**SUBJECT:** NuScale Power, LLC Response to NRC Request for Additional Information No. 205 (eRAI No. 9044) on the NuScale Design Certification Application

**REFERENCE:** U.S. Nuclear Regulatory Commission, "Request for Additional Information No. 205 (eRAI No. 9044)," dated September 01, 2017

NuScale Response to NRC Request for Additional Information eRAI No. 9044

**Figure 9.3.4-1: Chemical and Volume Control System Diagram**

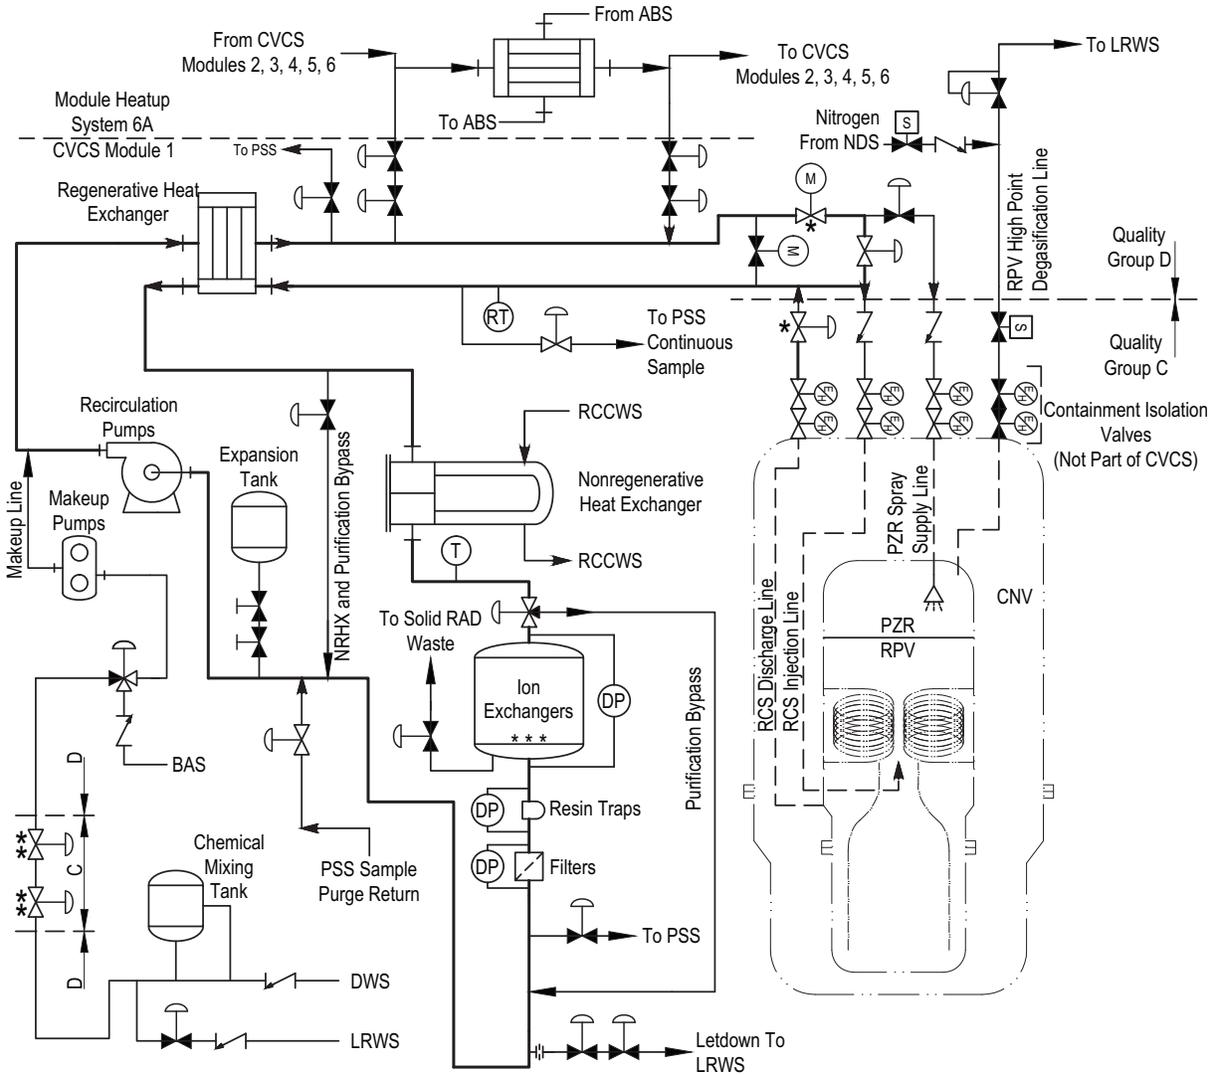
that the compressed air system (in addition to the nitrogen gas system) can provide gas to the Containment Evacuation System. It is unclear if this is where the nitrogen is being supplied from or if it is being supplied from elsewhere and how the design is adequate to ensure that nitrogen will push RCS fluid through the CVCS system and sampling line to the sampling point.

1. Please provide information sufficient to determine the source of the nitrogen and ensure that the pressure is sufficient to push the RCS fluid to the sampling point. As part of the response, provide information on minimum water levels in the reactor following design basis accidents, the CVCS system piping connection heights, and nitrogen injection point(s). Update the DCD to discuss how nitrogen injection is adequate to perform this task.

- b. Please describe in appropriate detail how the design prevents backflow into the instrument air system or how any backflow will not result in additional exposure to workers or additional release beyond what is accounted for in the accident analysis.

The instrument air system (IAS), depicted on FSAR Figure 9.3.1-1, supplies compressed air to operate pneumatically controlled valves and instrumentation in the NDS. The IAS does not supply nitrogen to the CNV to pressurize the containment for post-accident liquid RCS sampling, or supply compressed air directly to the containment evacuation system (CES) to pressurize containment. The IAS supplies compressed air to the service air system (SAS). The SAS is used to supply compressed air to the CNV through the reactor building (RXB) supply line to the CES to support draining the CNV prior to startup and to equalize CNV pressure with the refueling pool prior to unbolting the containment flange for disassembly. Backflow from the CNV to the compressed air system is controlled through the use of check valves in the SAS supply to the RXB and in the IAS supply to the SAS. Nitrogen backflow from RCS to the NDS is controlled using a check

valve on the nitrogen injection line to the RPV degasification line of the CVCS as shown on the updated FSAR Figure 9.3.4-1.

Revisions to FSAR Section 9.3.2.2.3 and FSAR Figure 9.3.4-1 in response to this RAI question are included with the response to RAI question 9.3.2-8.

At temperatures below 200 degrees Fahrenheit with RCS pressure insufficient to withdraw a sample, nitrogen can be injected into RCS to raise pressure and draw samples out of the reactor vessel. Nitrogen is provided via the nitrogen distribution system (NDS) connection to the RPV high point degasification line as shown on Figure 9.3.4-1.

Figure 9.3.6-2: Containment Flooding and Drain System Diagram

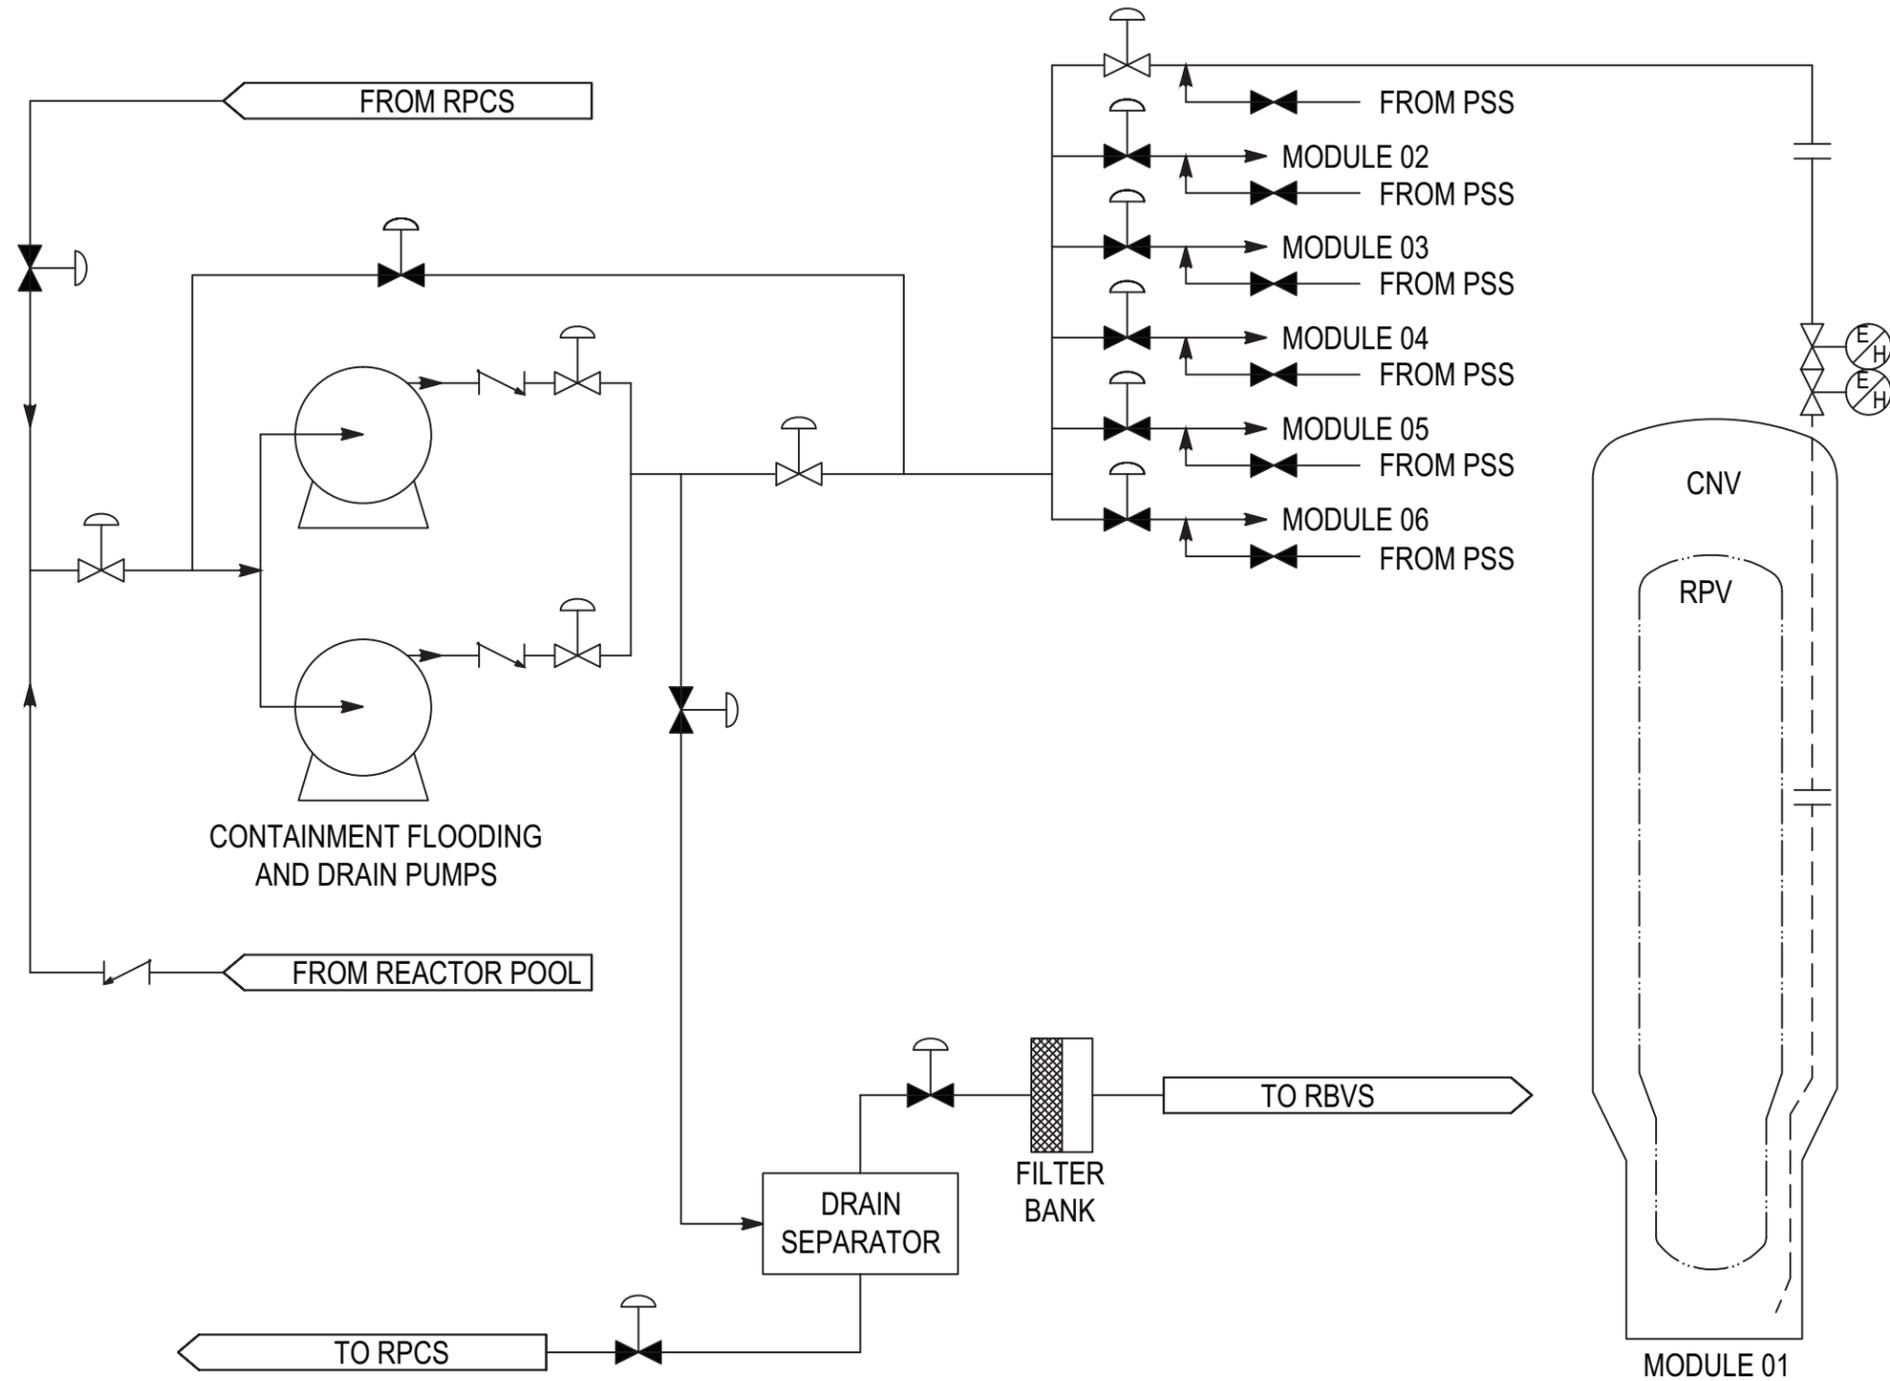
2. It is unclear which valves are required to be opened to take gaseous samples (only the CES or both the CES and CFDS?). Please clarify which valves need to be opened. If both CES and CFDS valves need to be opened to take gaseous samples, please clarify why the isolation valves for the CFDS (which goes to a part of the containment vessel that is expected to be submerged following an accident), needs to be opened to obtain a gas sample. Update the DCD as appropriate.

the CFDS provides the optimal return path for the gas discharged from the containment sampling system sample pump to the CNV. Therefore, opening of CFDS CIVs is required for returning the gas back to the containment. Returning the containment gas sample back to the CNV limits potential radioactive release outside of the containment. FSAR Figure 9.3.6-2 has been revised to show the PSS sample return line connection to the CFDS before the respective module isolation valve.

FSAR Sections 9.3.2.2.3 and 9.3.2.5 and FSAR Figure 9.3.6-2 have been revised to clarify the post-accident sampling process and equipment required to support sampling. The FSAR changes referred to in this RAI are included with the response to RAI 9.3.2-8.

(CFDS) piping and valves, downstream of the CFDS return-side NPM isolation valves [as shown on Figure 9.3.6-2](#).
